SEARS

NAVIX PROJECT NUMBER: 50-215-004

7414 78TH AVE SE
MERCER ISLAND, WA 98040

ENGINEERS' CONSTRUCTION RECORD CERTIFICATION

C5.01

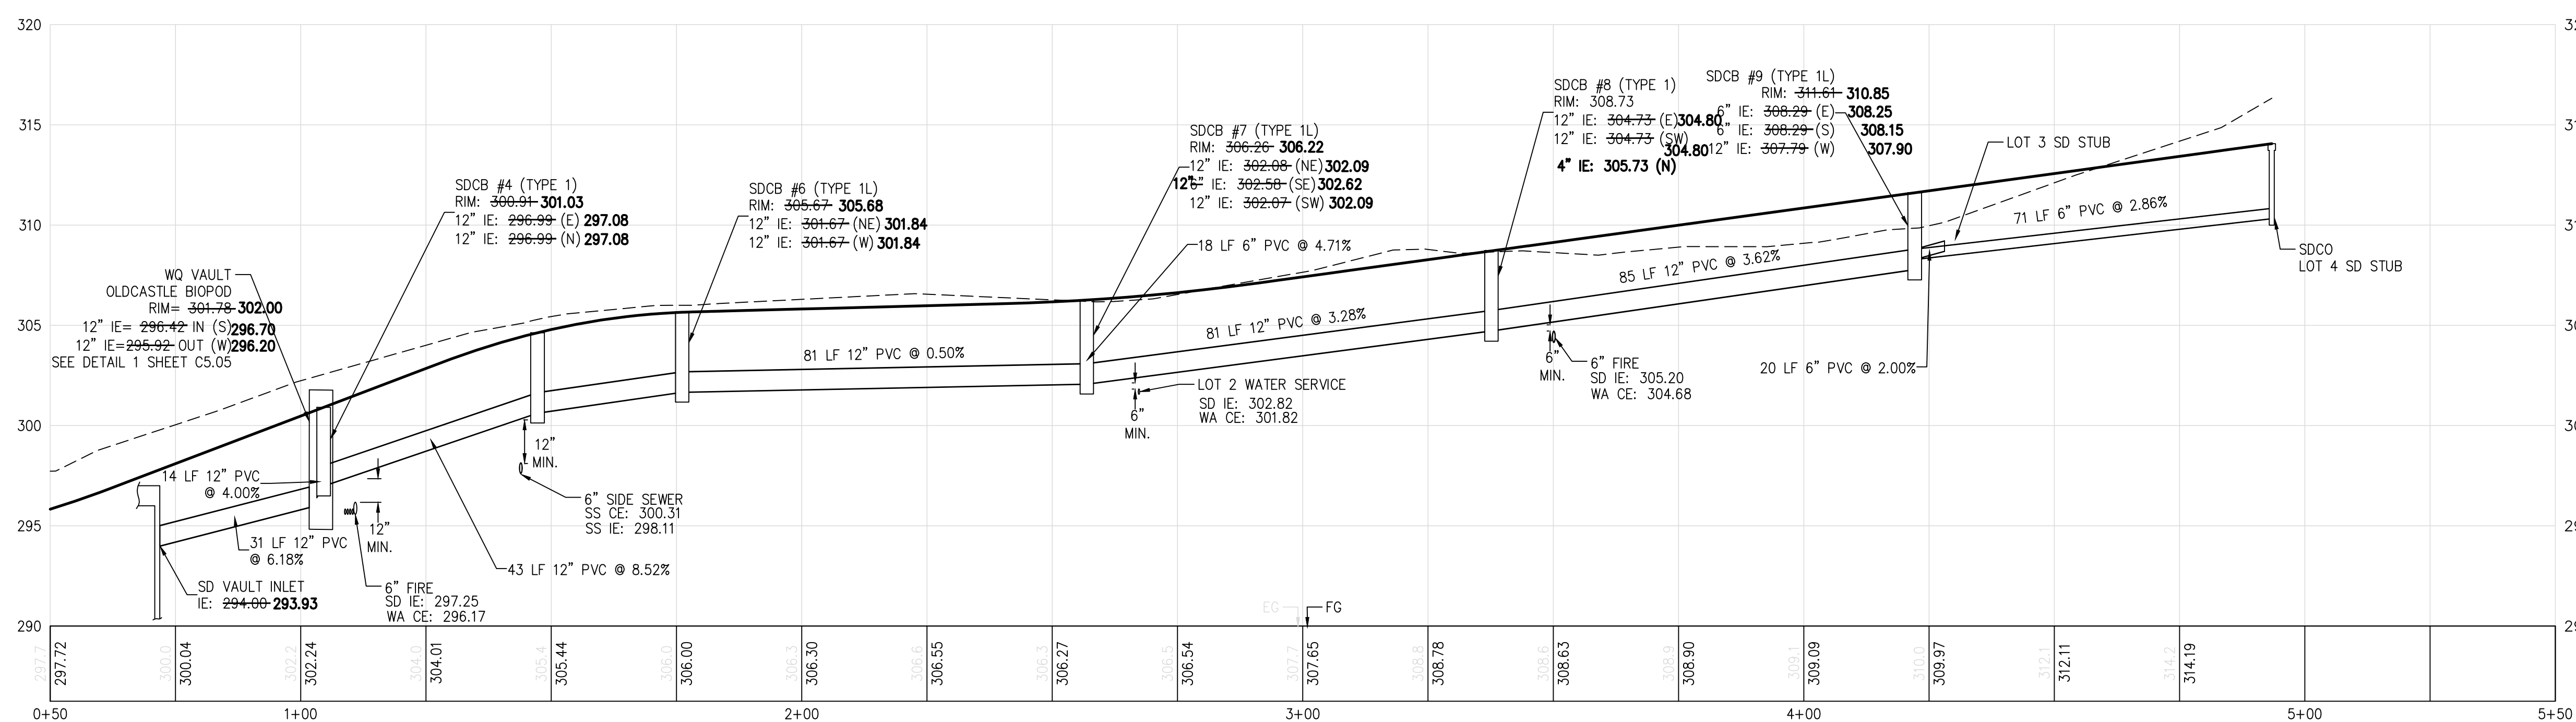
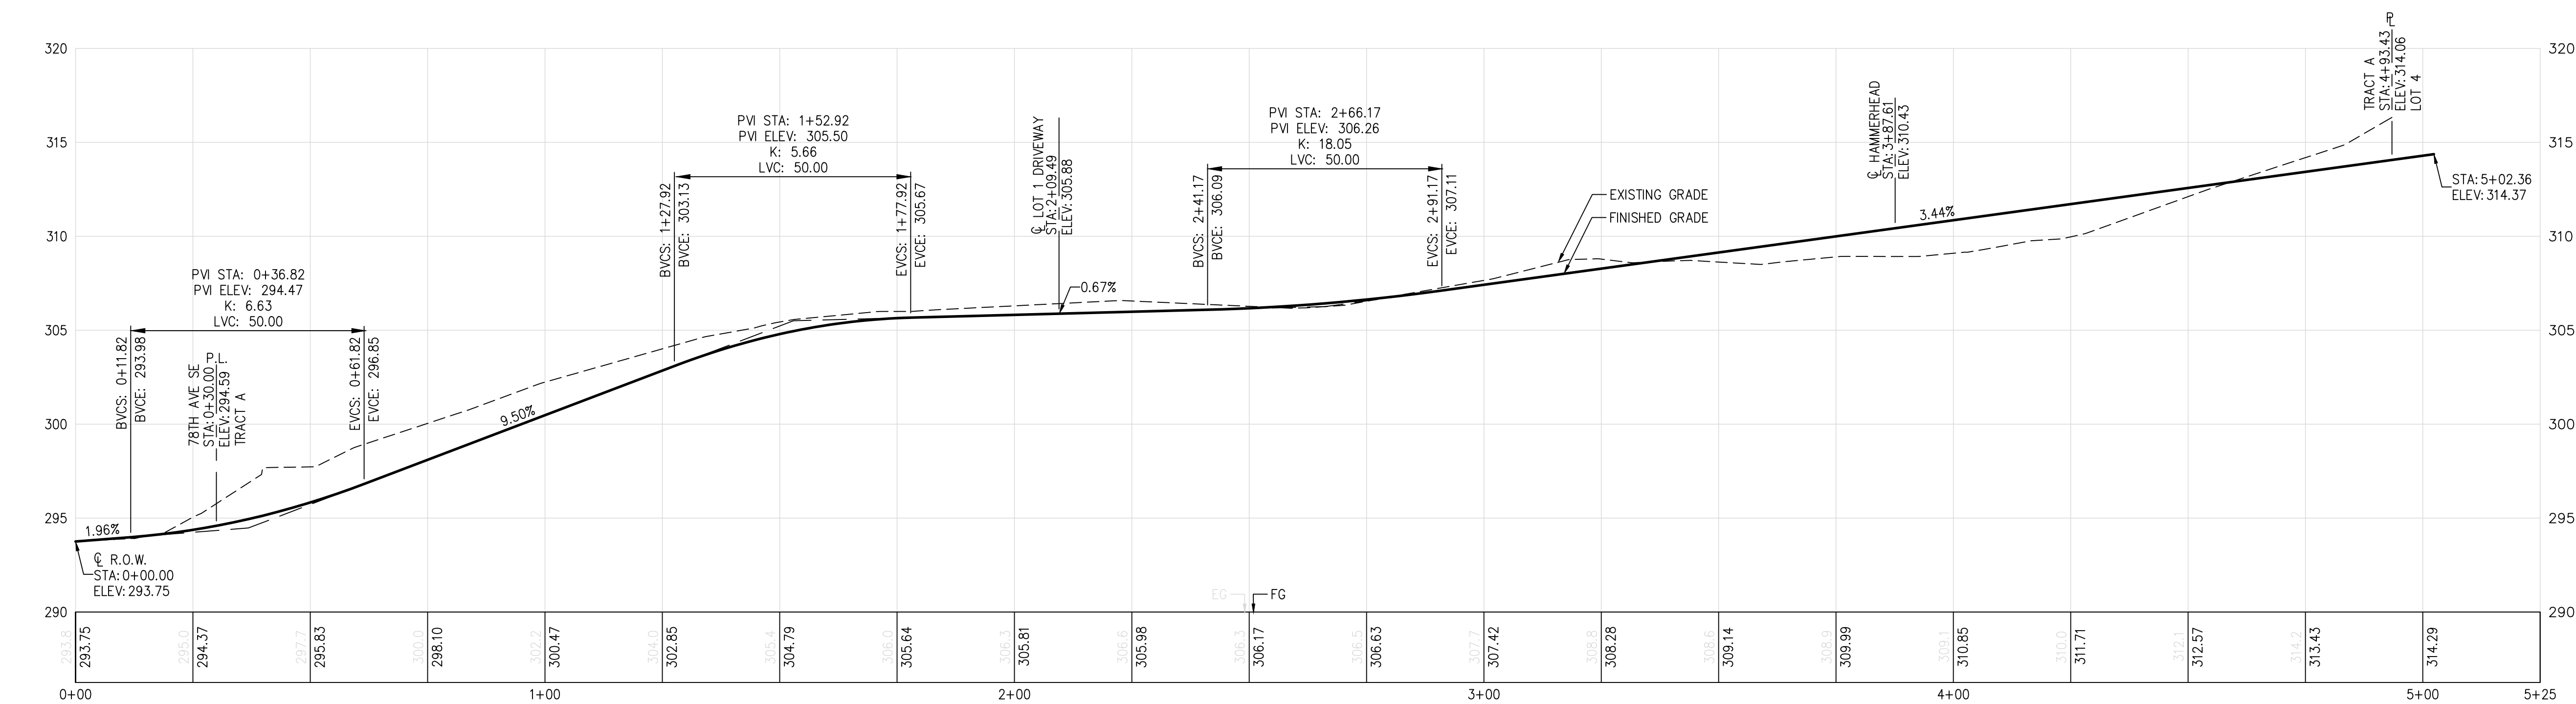
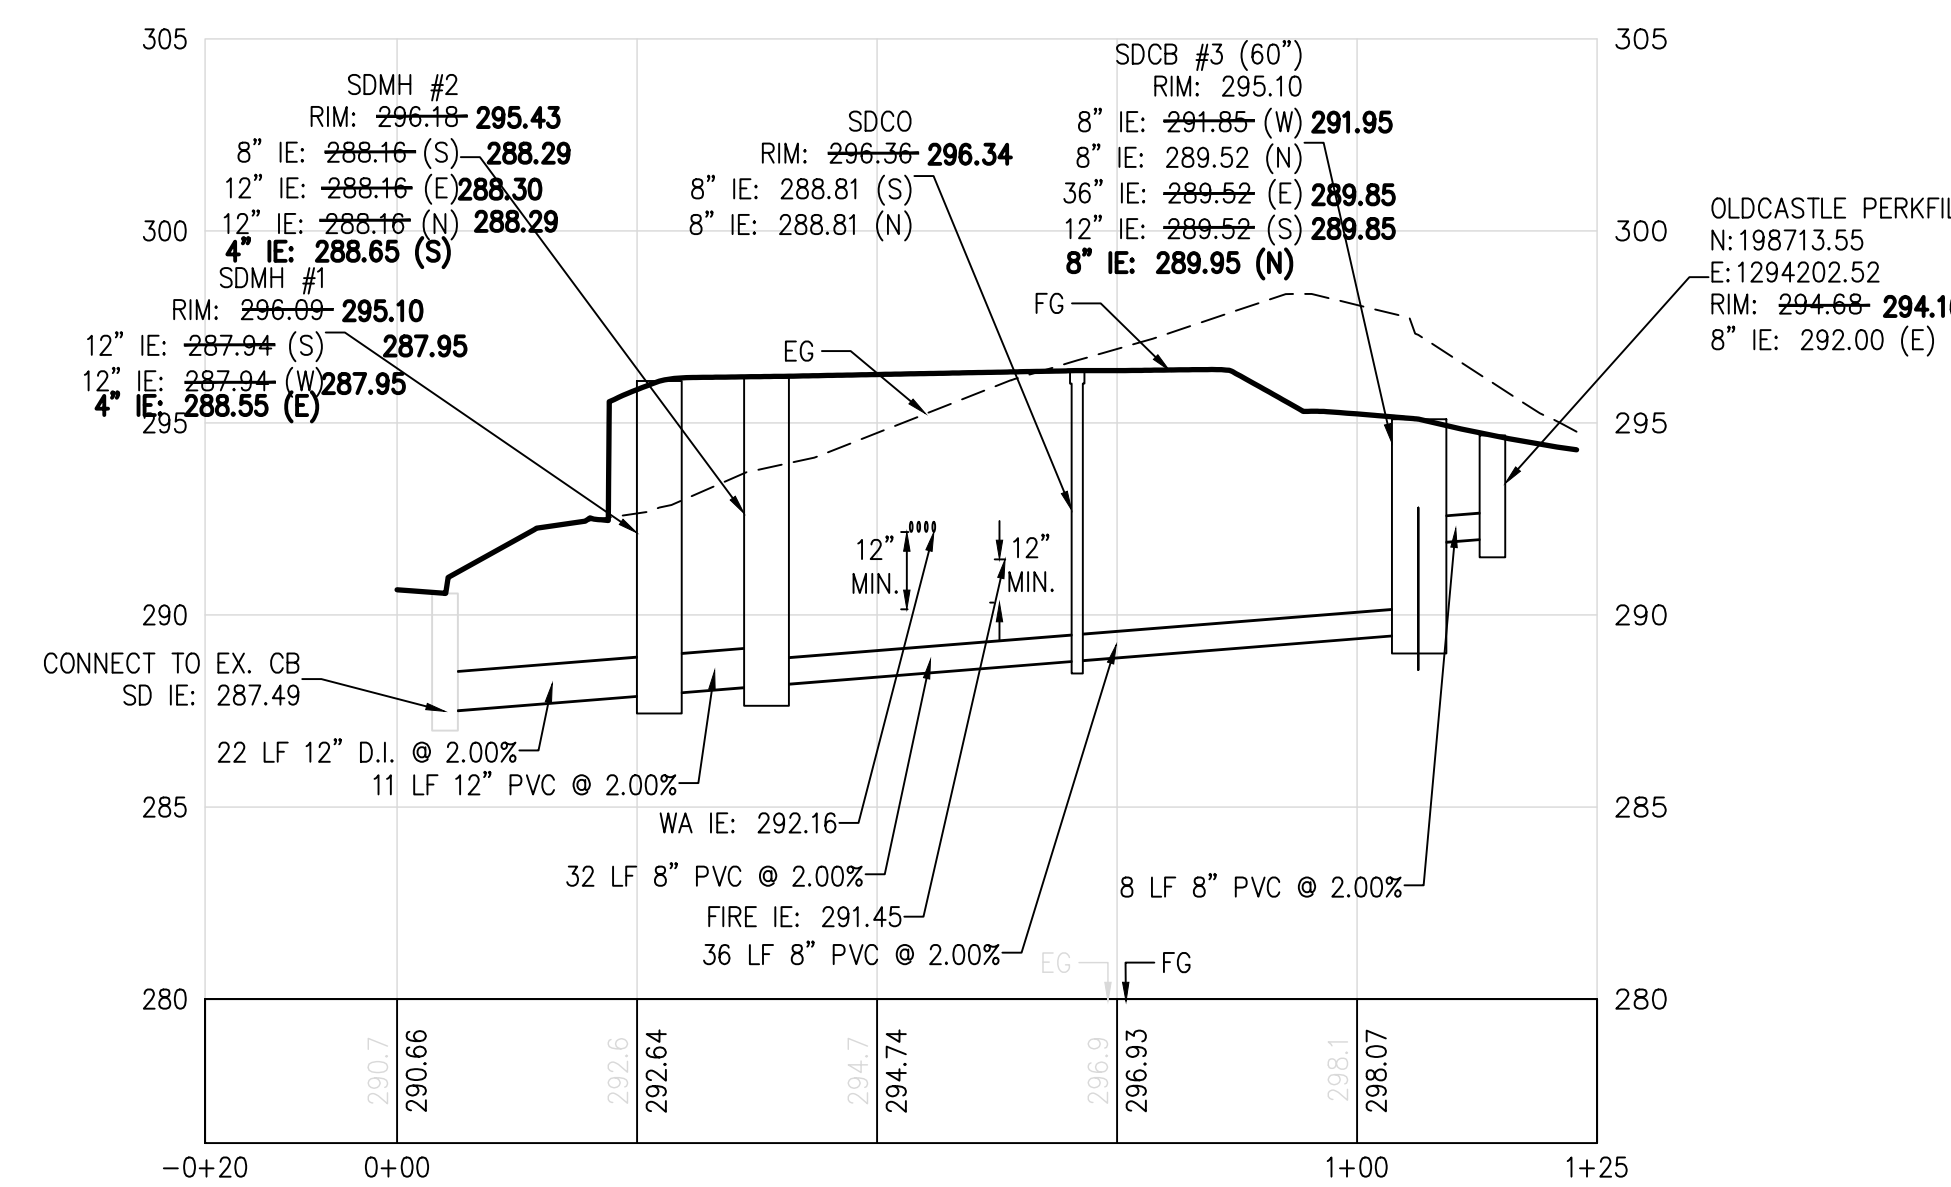
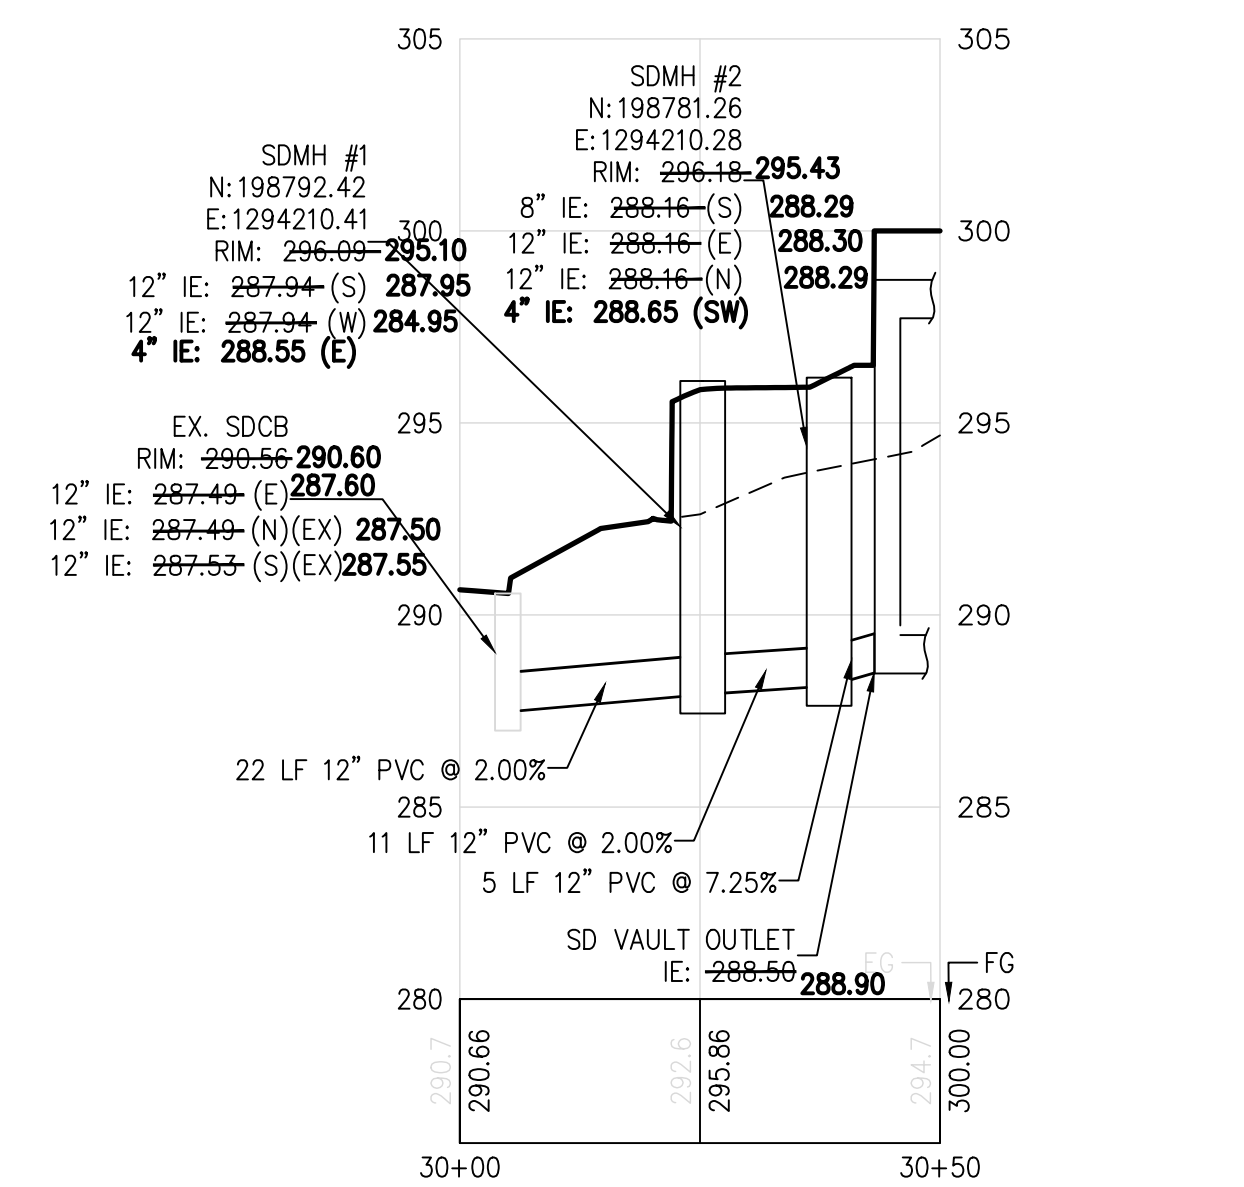
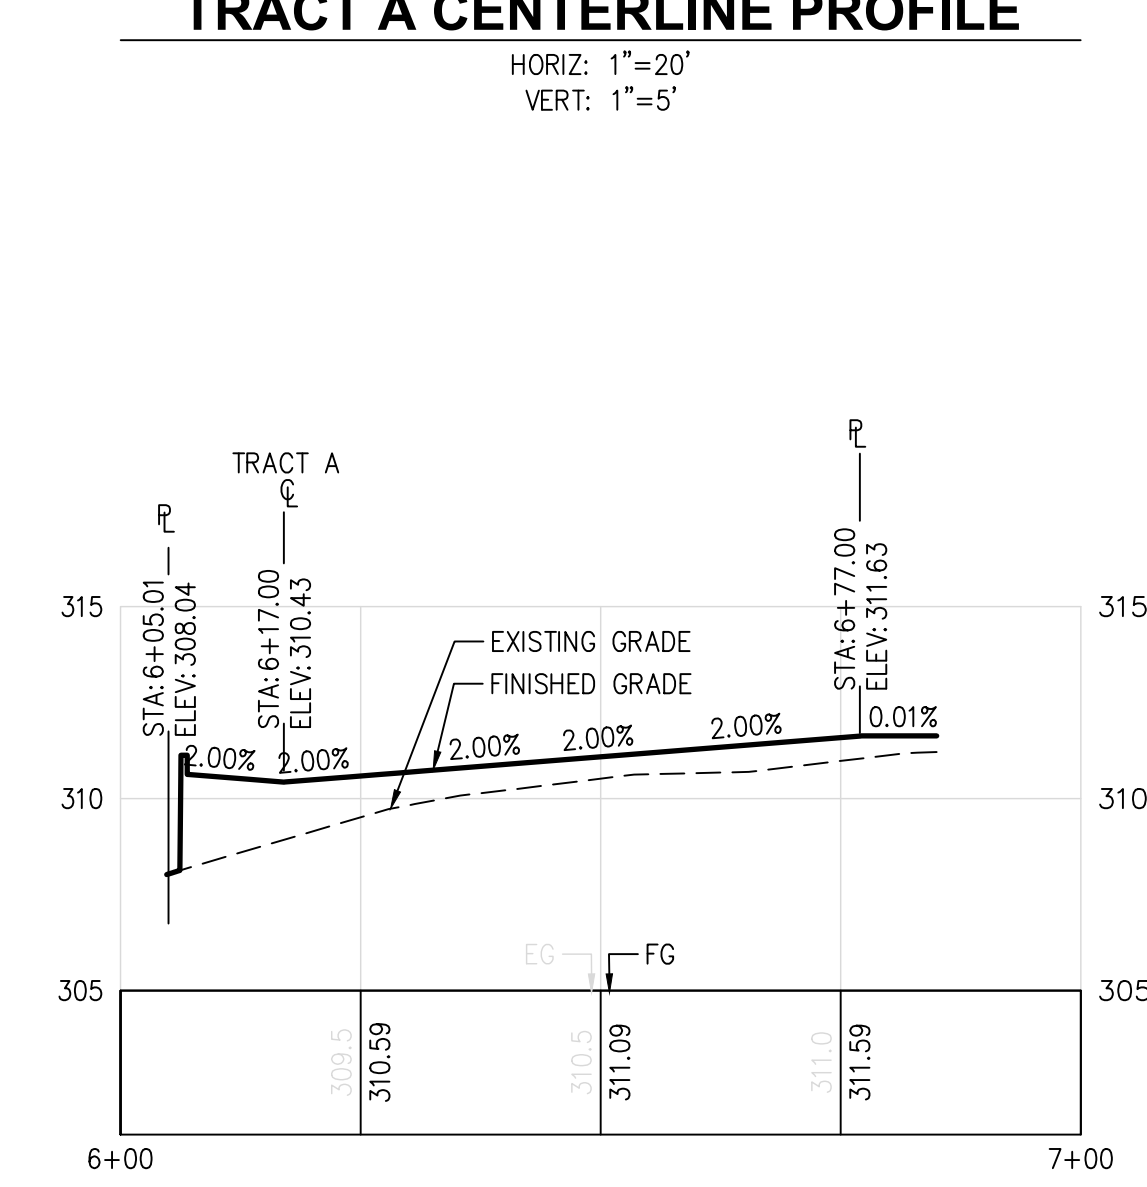
1	EX. SDCB (SEE NOTE 2) N:198792.64 E:1294188.05 RIM: ~~296.56~~ 290.60 12" IE: ~~267.49~~ (E) 287.60 12" IE: ~~267.49~~ (N) 287.50 12" IE: ~~267.53~~ (S) 287.55	3	SDCB #7 (TYPE 1L) RIM: ~~306.26~~ 306.22 12" IE: ~~302.08~~ (NE) 302.09 12" IE: ~~302.58~~ (SE) 302.62 12" IE: ~~302.07~~ (SW) 302.09	18	LOT 3 SD STUB N:198757.28 E:1294585.37 6" IE: ~~308.73~~ (N) 308.71
2	SDMH #1 (48") (TYPE 3 W/ SOLID LID) N:198792.42 E:1294210.41 RIM: ~~296.69~~ 295.10 12" IE: ~~267.94~~ (S) 287.95 12" IE: ~~267.94~~ (W) 287.95 4" IE: ~~266.30~~ (E) 288.55	10	SDCB #8 (TYPE 1) RIM: 308.73 12" IE: ~~304.73~~ (E) 304.80 12" IE: ~~304.73~~ (SW) 304.80 4" IE: ~~306.06~~ (N) 305.73	19	LOT 4 SD STUB N:198774.54 E:1294723.83 6" IE: ~~313.50~~ (W) 314.06
3	Vault Outlet 12" IE: ~~288.56~~ (W) 288.96 4" IE: 288.50 (NW) FTG	11	SDCB #9 (TYPE 1L) RIM: ~~311.61~~ 310.65 6" IE: ~~308.29~~ (E) 308.25 6" IE: ~~308.81~~ (S) 308.15 12" IE: ~~307.79~~ (W) 307.90	20	SDCO #2 N:198776.26 E:1294649.02 RIM: 314.06 6" IE: 310.33 (E) 6" IE: 310.33 (W)

4	Vault Inlet 12" IE: ~~294.90~~ (E) 293.93	12	FIRE BACKFLOW VALVE WITH 4" DRAIN AND UNDERDRAIN 4" PERF PIPE W-19 C6.04	21	SDMH #2 (48") (TYPE 3 W/ SOLID LID) N:198781.26 E:1294210.28 RIM: ~~296.18~~ 295.43 8" IE: ~~289.16~~ (S) 288.29 12" IE: ~~288.16~~ (E) 288.30 12" IE: ~~288.16~~ (N) 288.29 4" IE: ~~288.50~~ (S) 288.65
5	WO#1 OLDCASTLE BIO-POD N:198728.62 E:1294275.07 RIM: ~~301.77~~ 302.00 (C5.05) 12" IE: ~~296.42~~ (S) 296.70 12" IE: ~~296.92~~ (W) 296.20 4" PVC IE: ~~296.25~~ (E)	13	SDCO #1 N:198748.89 E:1294210.97 RIM: ~~296.36~~ 296.34 8" IE: 288.81 (N) 8" IE: 288.81 (N)	22	SDCB #3 (60") (TYPE 2 W/ SOLID LID) N:198713.37 E:1294210.16 RIM: 295.10 8" IE: ~~291.85~~ (W) 291.95 8" IE: 289.52 (N) 36" IE: ~~289.52~~ (E) 289.85 12" IE: ~~289.52~~ (S) 289.85 8" IE: 289.95 (N)
6	SDCB #4 (TYPE 1) RIM: ~~300.91~~ 301.03 12" IE: ~~296.99~~ (E) 297.08 12" IE: ~~296.99~~ (N) 297.08	14	WO#2 OLDCASTLE PERKFILTER CB N:198713.55 E:1294202.52 RIM: ~~294.68~~ 294.16 8" IE: 292.00 (E)	23	SDCB #4 (60") (TYPE 2 W/ SOLID LID) N:198707.59 E:1294210.02 RIM: ~~295.25~~ 295.16 12" IE: ~~289.52~~ (N) 290.91 36" IE: ~~289.52~~ (E) 290.91

7	SDCB #5 (TYPE 1) RIM: ~~304.63~~ 304.75 12" IE: ~~300.63~~ (E) 300.75 12" IE: ~~300.63~~ (W) 300.75 6" IE: ~~301.13~~ (N) 301.00	15	4" PERFORATED DRAIN PIPE	24	SDCB #5 (60") (TYPE 2 W/ SOLID LID) N:198712.32 E:1294255.45 RIM: ~~299.02~~ 299.06 36" IE: ~~289.52~~ (W) 290.06 6" IE: ~~295.70~~ (SE) 295.66
8	SDCB #6 (TYPE 1L) RIM: ~~305.67~~ 305.68 12" IE: ~~301.67~~ (NE) 301.84 12" IE: ~~301.67~~ (W) 301.84	17	LOT 2 SD STUB N:198728.87 E:1294427.80 6" IE: ~~303.42~~ (NW) 303.40
